PHAP15-00040

Date: October 12, 2015
Application Type: Certificate of Appropriateness
Property Owner: Martin Building LLC
Representative: Martin Building LLC
Legal Description: Being 5 Mills 20 ft. on Mills X 80 ft. Beg. 95 ft. W. of NEC (1600 sq. ft.)
City of El Paso, El Paso County, Texas
Historic District: Downtown
Location: 114-A Mills Avenue
Representative District: #8
Existing Zoning: C-5/H (Commercial/Historic)
Year Built: 1948
Historic Status: Landmark
Request: Certificate of Appropriateness for the installation of a sign and the installation of a metal screen/fence after-the-fact
Application Filed: 10/7/2015
45 Day Expiration: 11/21/2015

Certificate of Appropriateness for the installation of a sign and the installation of a metal screen/fence after-the-fact

A4.1

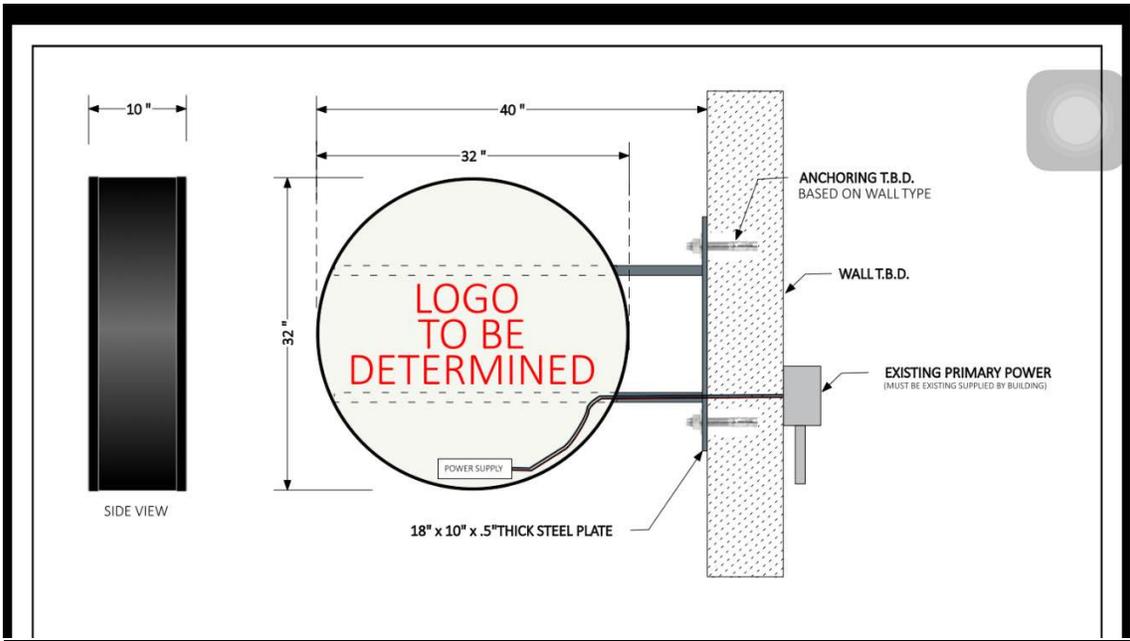
The Historic Preservation Office recommends APPROVAL WITH A MODIFICATION of the proposed scope of work based on the following recommendations:

- *Signs should not hide or cover any significant detailing and/or architectural detailing and/or architectural features of the building.*
- *On-premise signage should not cover windows, doors, or air vents.*

- *On-premise signs should be located in close proximity to the activity it is identifying. In most cases, the best location is usually above, on, and/or near the front door.*

- *Signs shall not exceed thirty square feet in all commercial and manufacturing districts, and should not exceed six feet in height.*
- *Signs constructed for landmark buildings or sites must be made of materials attributed to the year in which the buildings or site was constructed.*
